FLEET OPERATIONS

February 28, 2014

Attention: BC Ambulance Service Representative

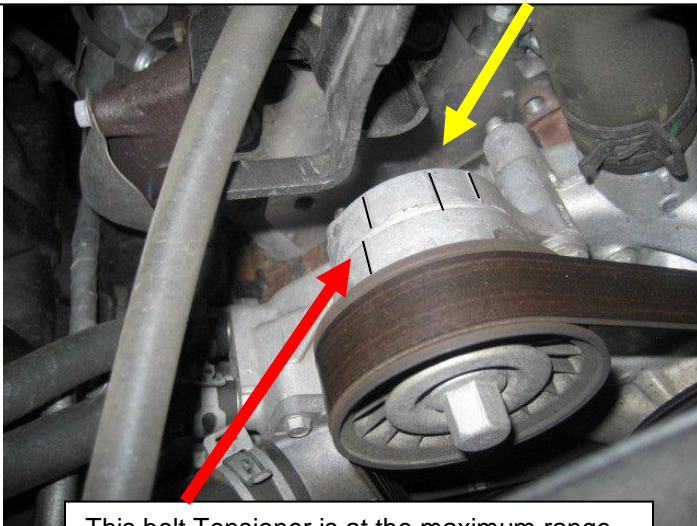
There have been instances on the Chevrolet gasoline engine ambulances where the serpentine belt prematurely wears and emits an audible chipping noise. Due to inconsistencies during manufacturing, ambulance manufacturers may have installed an incorrect sized idler pulley between the two alternators.

If your Chevrolet gasoline engine belt tensioner has exceeded the maximum position as shown in the picture – Contact the ambulance manufacturer (Crestline or Demers) for the correct idler pulley (and belt) for warranty replacement.

Belt Tensioner hash mark needs to be in the middle range

This belt Tensioner is at the maximum range

Idler pulley in question

At the next scheduled A service inspect the serpentine belt tensioner for correct positioning.
